To: Kristopher Byrd, Well Construction and Compliance Section Manager
From: Travis Kelly, Well Construction Program Coordinator
Subject: Review of Water Right Application G-19201
Date: February 4, 2022

Application # G- 19201

PUBLIC INTEREST REVIEW FOR GROUNDWATER APPLICATIONS

Theis Distance Drawdown Modeling

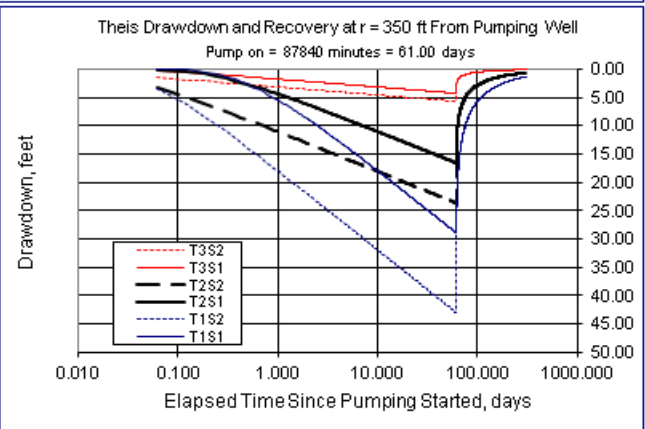
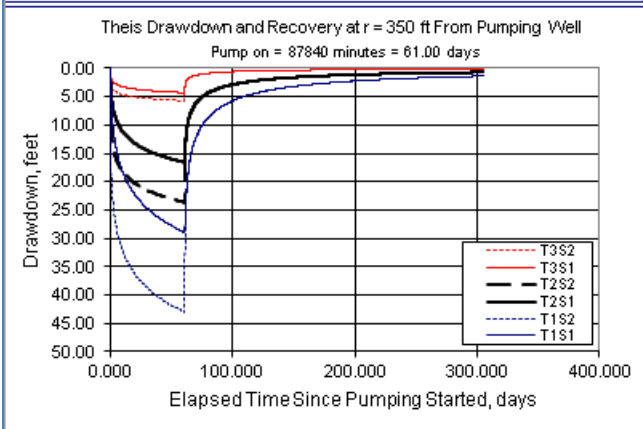
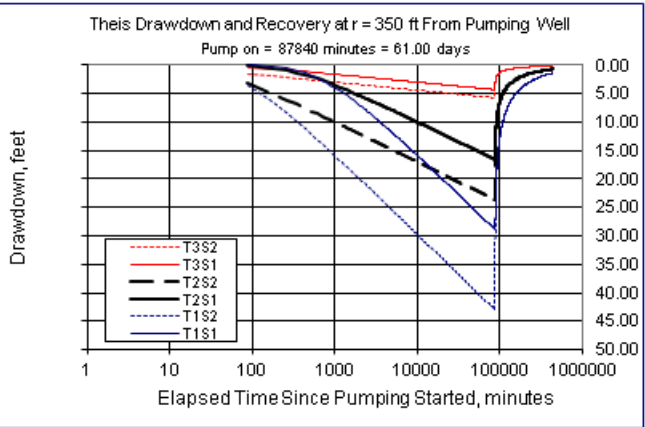
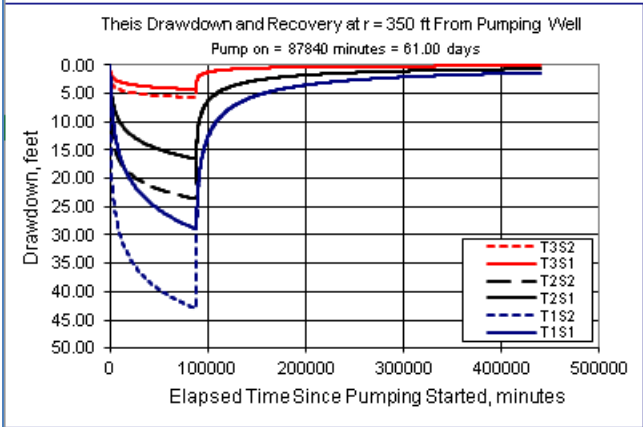
The closest groundwater uses are likely exempt-use wells supplying adjacent tax lots 600, 700, 800, and 1100 at a minimum range of 350-400 feet from JACK 64922. A Theis distance drawdown model is used to estimate the magnitude of any well-to-well interference that may result from the proposed use. Results indicate that this use could cause 5-25 feet of drawdown in adjacent wells, but this is not considered a preponderance of evidence that the proposed use would injure these adjacent wells.

The pumping rate below is half the permitted rate (an expected sustainable pumping rate for the well) in use for the entire period of use (61 days). Model parameters are estimates of bulk aquifer properties in the Hornbrook Formation based on published values for flow in fractured sedimentary aquifers.
